U.S. Department of the Interior BUREAU OF LAND MANAGEMENT

Well Name: NIMITZ MDP1 13\_1 Well Location: T24S / R30E / SEC 13 / County or Parish/State: EDDY /

Type of Submission: Notice of Intent

Type of Action: APD Change

#### WELL LOCATION AND ACREAGE DEDICATION PLAT

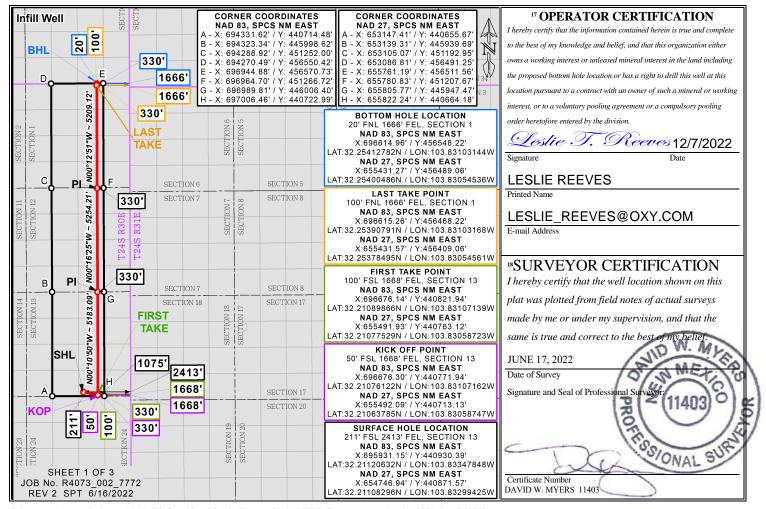
**Procedure Description:** OXY USA Inc. respectfully requests approval to amend the subject well AAPD. See the below new BHL, the attached well plat showing the new wolfcamp pool and HSU, and the updated drill plan for reference. OLD BHL: 20' FNL 2270' FEL Lot 2-Sec. 1-T24S-R30E NEW BHL: 20' FNL 1666' FEL Lot 2-Sec. 1-T24S-R30E

UL or lot no.	Section	Township	Range	Lot Idn	Feet from the	North/South line	Feet from the	East/West line	County
L 2	1	24S	30E		20	NORTH	1666	EAST	EDDY
12 Dedicated Acres	<sup>13</sup> Joint or	Infill 14 C	Consolidation	Code 15 Or	der No.				
959.9
